STATE OF FLORIDA
DEPARTMENT OF TRANSPORTATION

STATE ROAD NO. 45
(US41/50TH ST.) FROM N. OF 27TH AVE. S.
TO N. OF E. 10TH AVE.

SIGNALIZATION PLANS

*"The above named professional engineer shall be responsible for the following changes, indicated in redline revision, in accordance with **Rule 61G15-23.004, F.A.C.** This project was constructed in substantial compliance with these plans as provided by the Engineer of Record."*

SIGNALIZATION PLAN
SELMON EXPWY WB

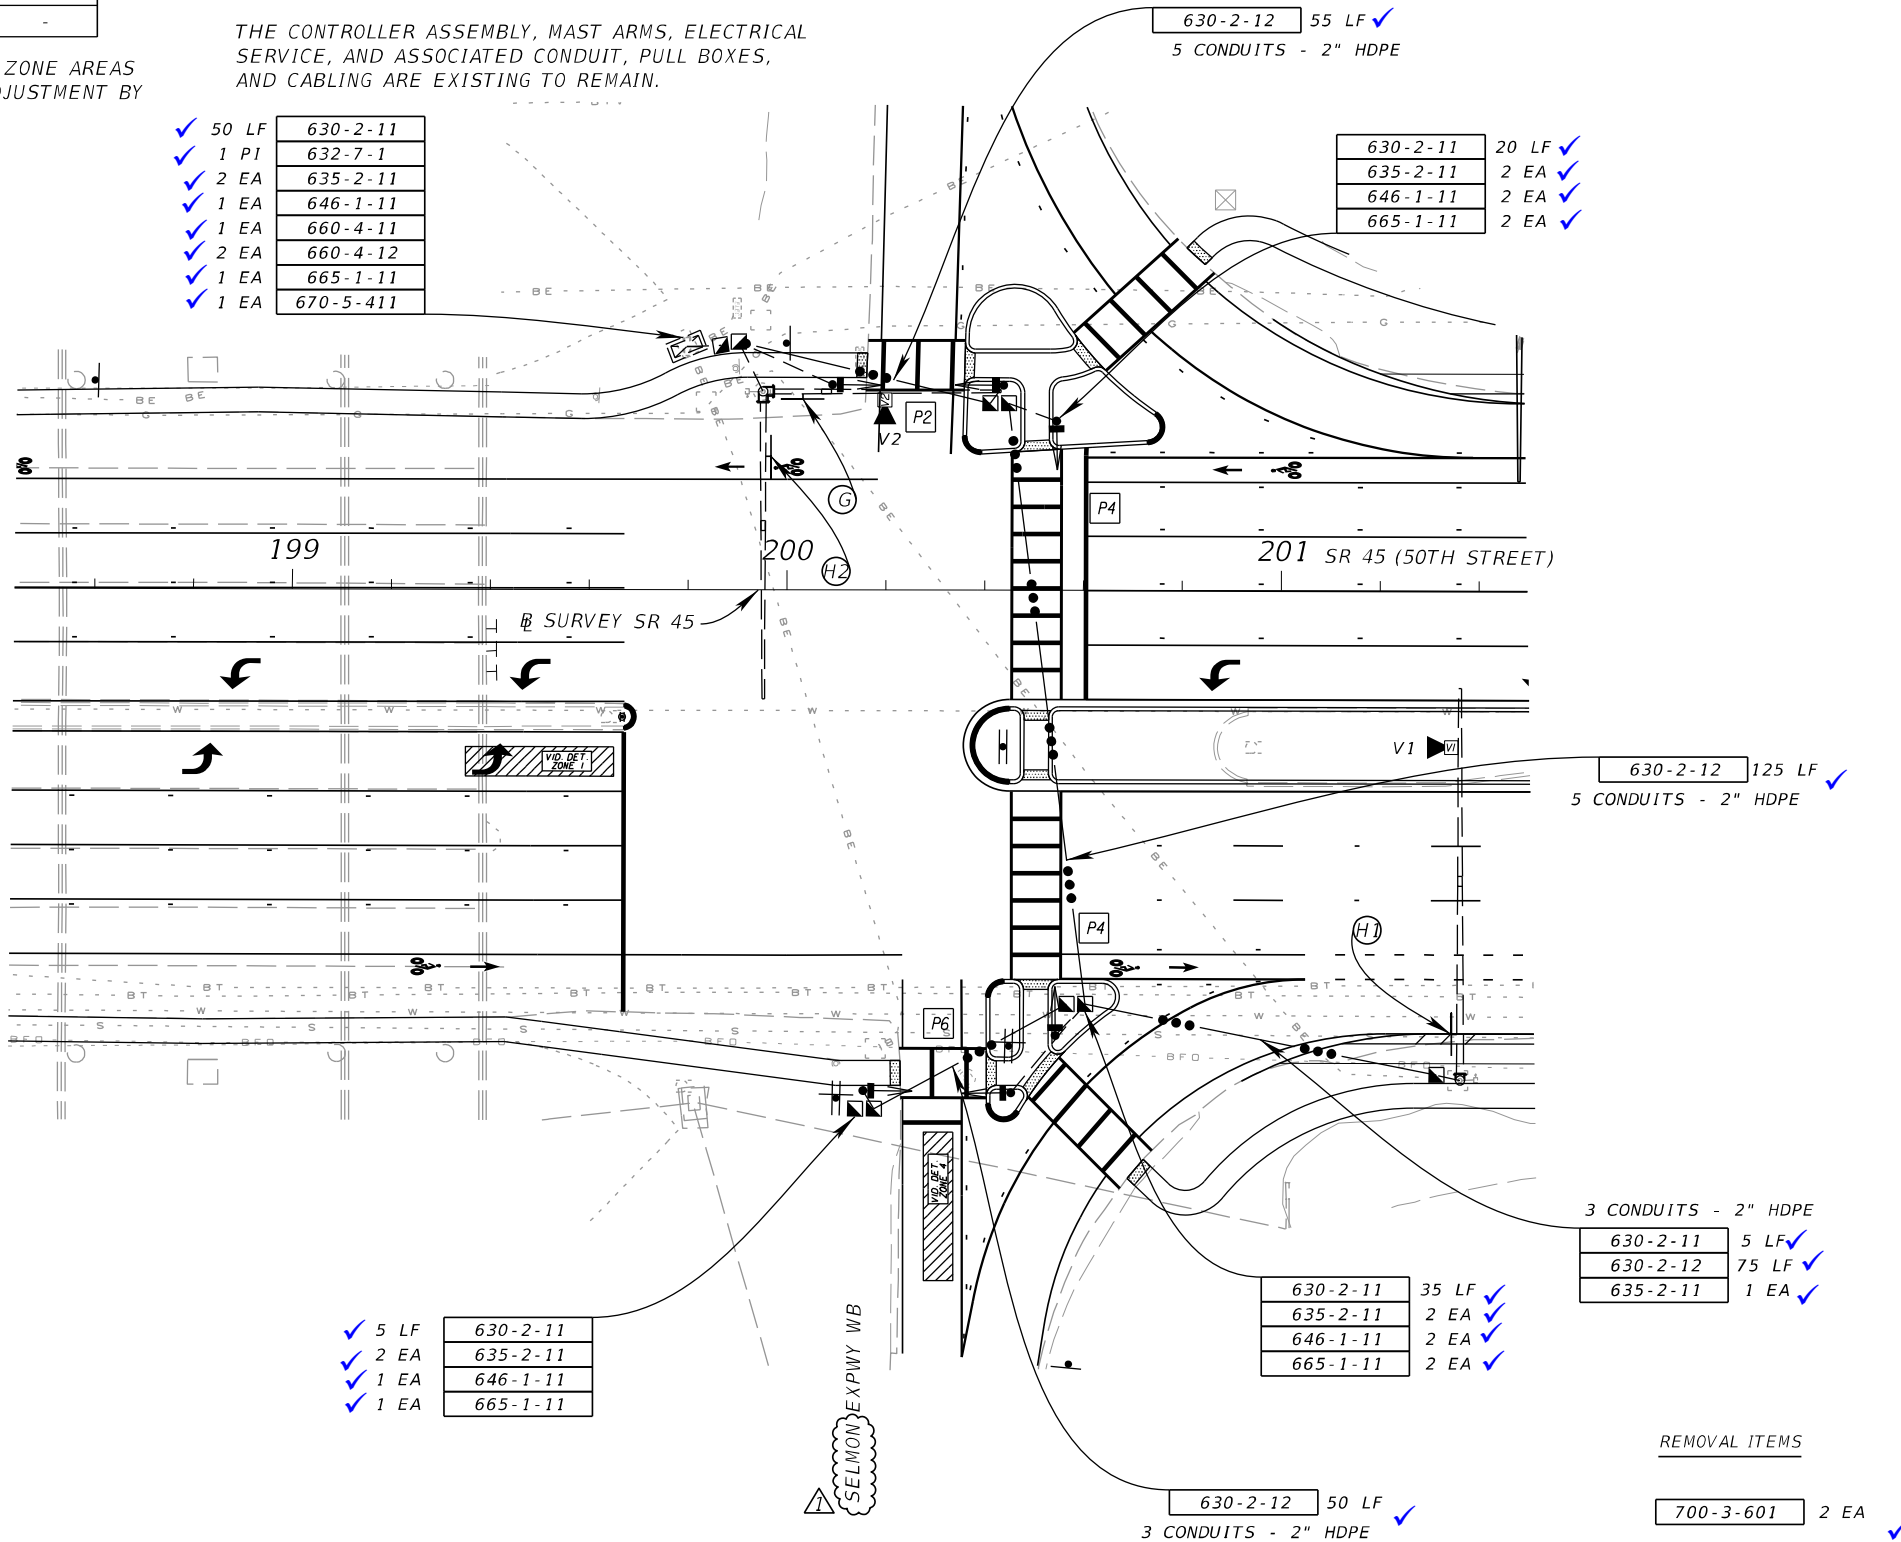
DATE	DESCRIPTION	DATE	DESCRIPTION
06/24/15	1 CHANGED "CROSSTOWN" TO "SELMON".

T-9

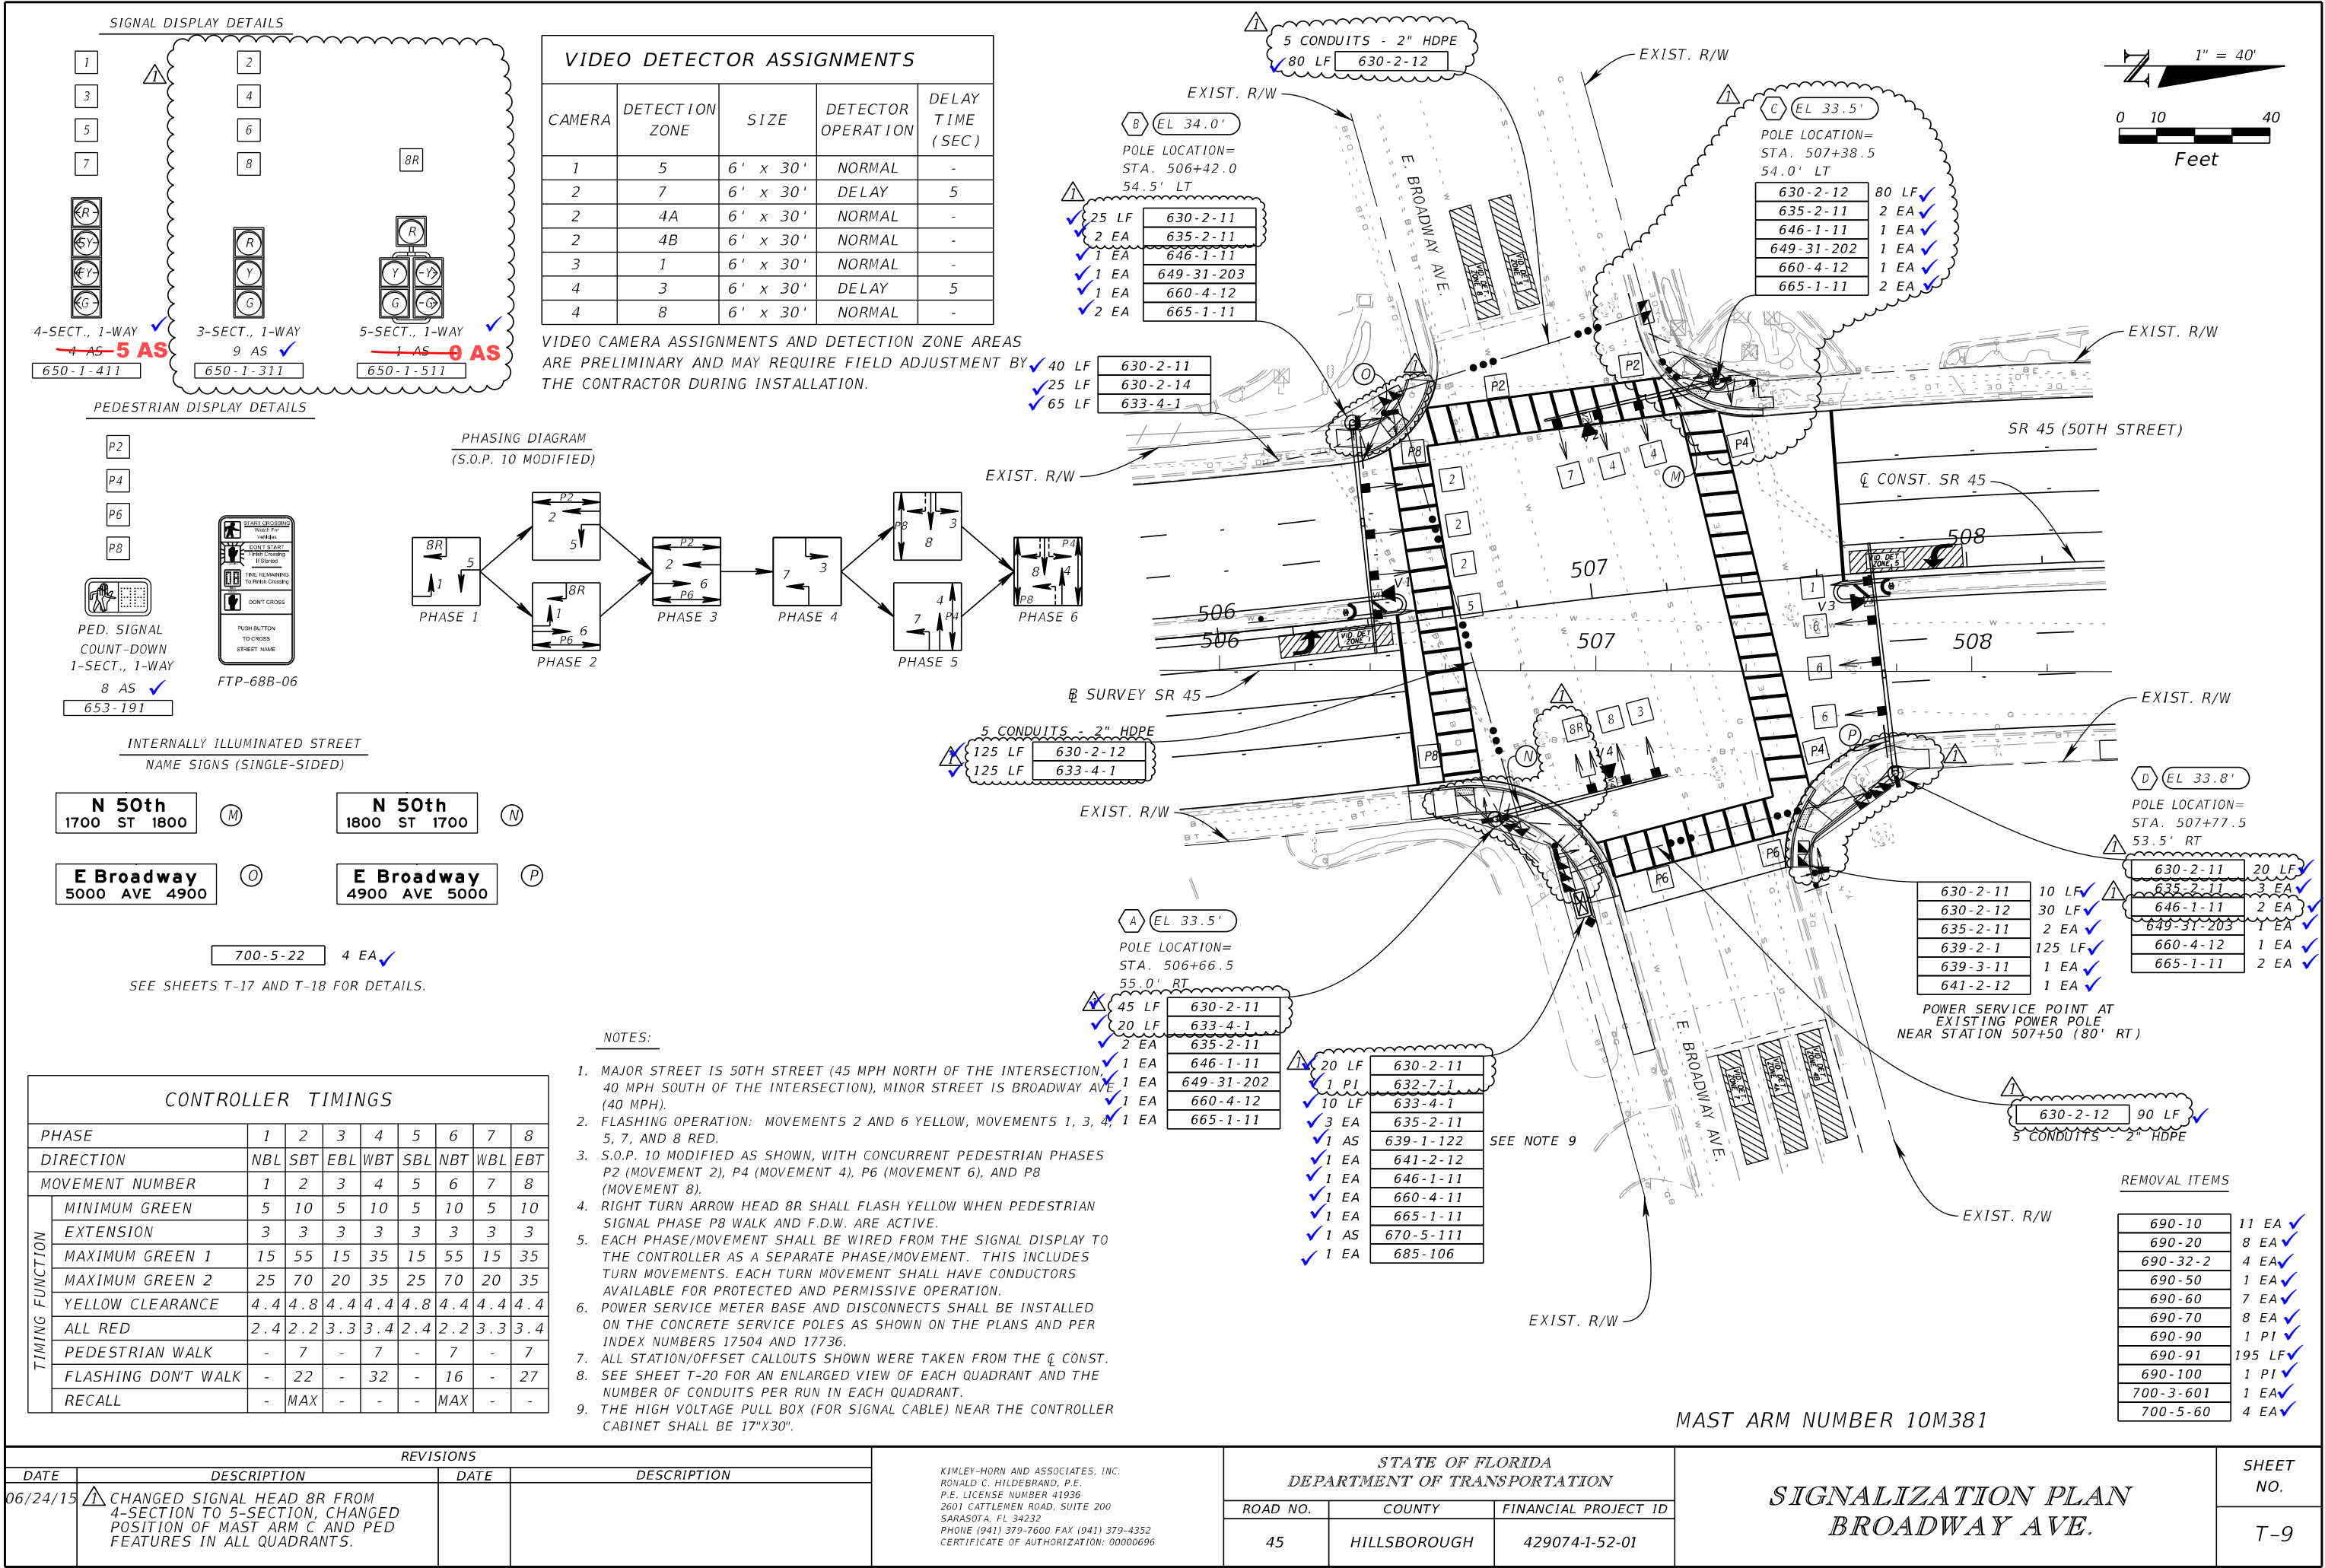
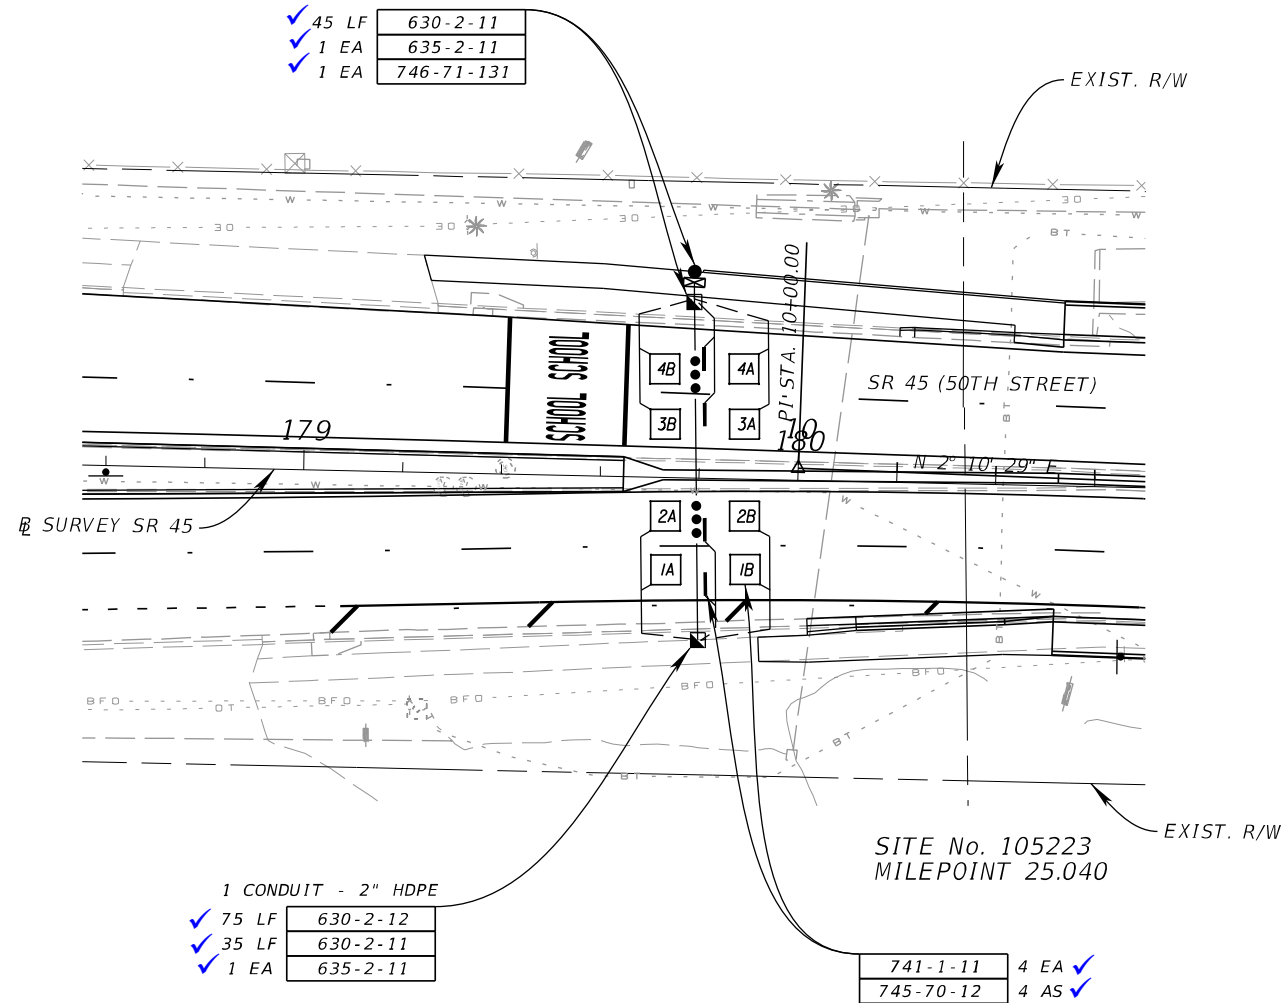
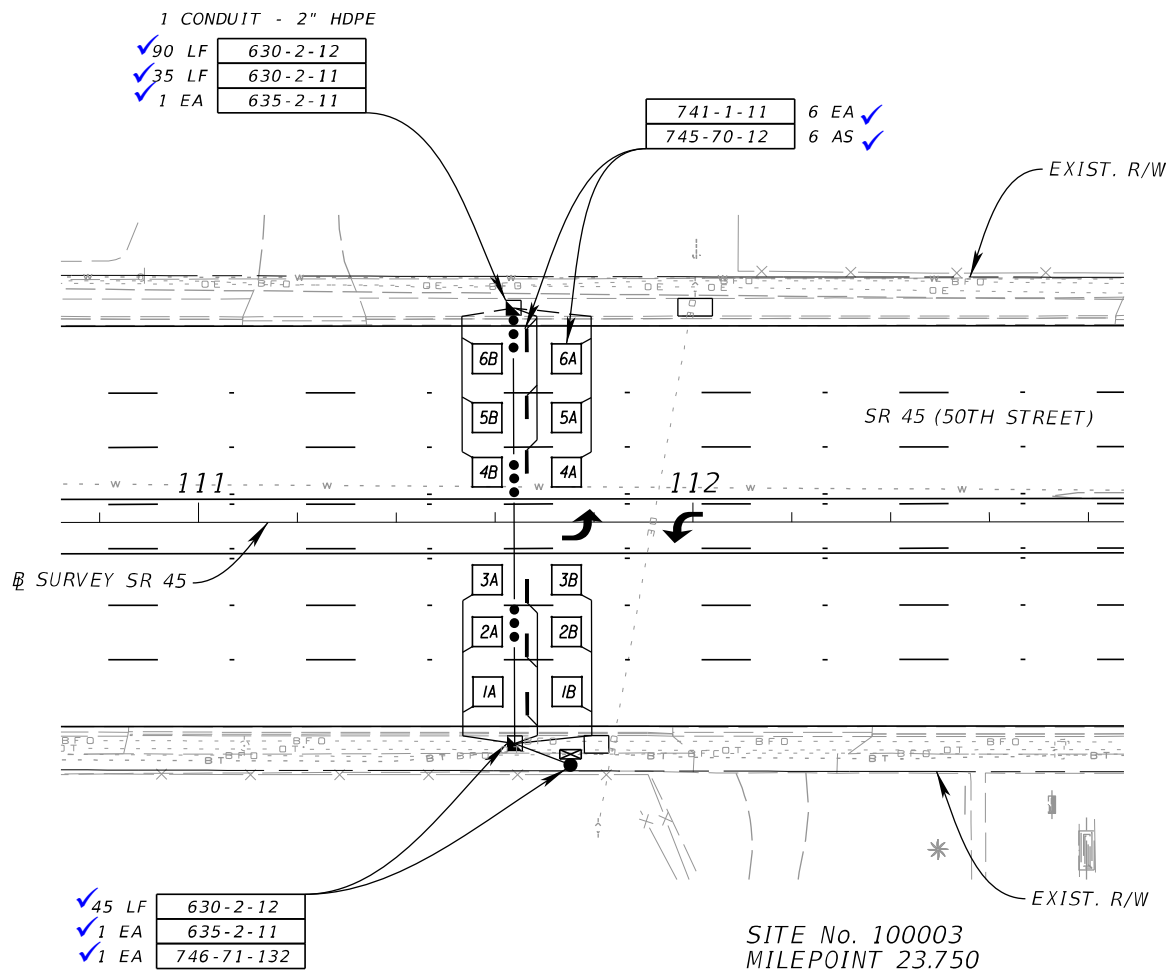
<u>Sheet No.</u>	<u>Sheet Description</u>
T-9	Signal Change

REVISIONS				KIMLEY-HORN AND ASSOCIATES, INC. RONALD C. HILDEBRAND, P.E. P.E. LICENSE NUMBER 41936 2601 CATTLEWEN ROAD, SUITE 200 SARASOTA, FL 34232 PHONE (941) 379-7600 FAX (941) 379-4352 CERTIFICATE OF AUTHORIZATION: 00000696	STATE OF FLORIDA DEPARTMENT OF TRANSPORTATION			TABULATION OF QUANTITIES	SHEET NO.
DATE	DESCRIPTION	DATE	DESCRIPTION		ROAD NO.	COUNTY	FINANCIAL PROJECT ID		T-2
06/24/15	△ CHANGED SIGNAL HEADS ON SHEETS T-5 AND T-9, CHANGED POSITION OF MAST ARM C. PED FEATURES, AND CONDUITS ON SHEET T-9.				45	HILLSBOROUGH	429074-1-52-01
